減速比分析 20250916

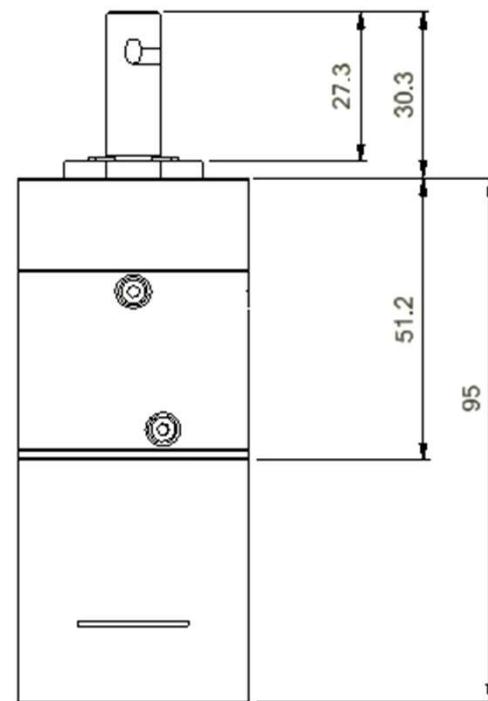
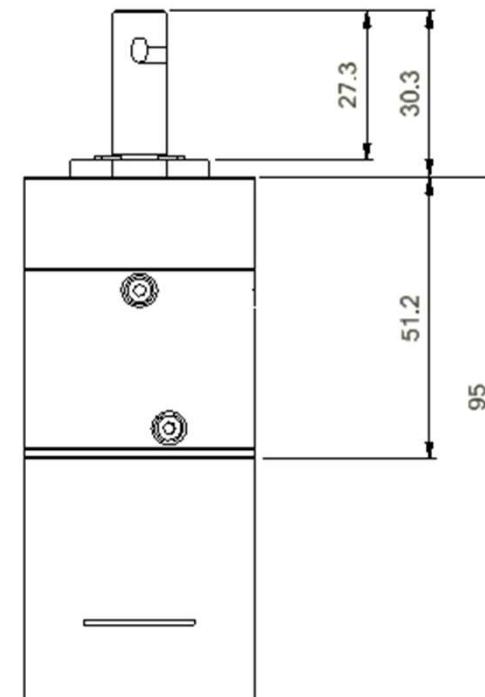
- 目前減速比29
- 馬達轉速5800 RPM
- 輸出軸轉速 200 RPM

- 減速比改**46**
- 馬達轉速**5800 RPM**
- 輸出軸轉速 **126 RPM**

修改狀況：

目前料件輸出軸回廠修改，**增加輸出軸修改費用**
產品總成本不變
產品外觀尺寸均不變

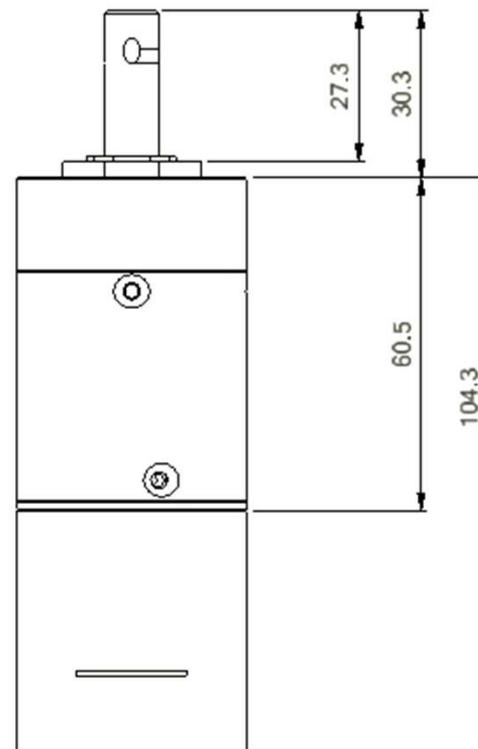
- 減速比改**79**
- 馬達轉速**5800 RPM**
- 輸出軸轉速 **73 RPM**

修改狀況：

產品總成本增加一階齒輪成本
產品外觀尺寸多增加9.3mm
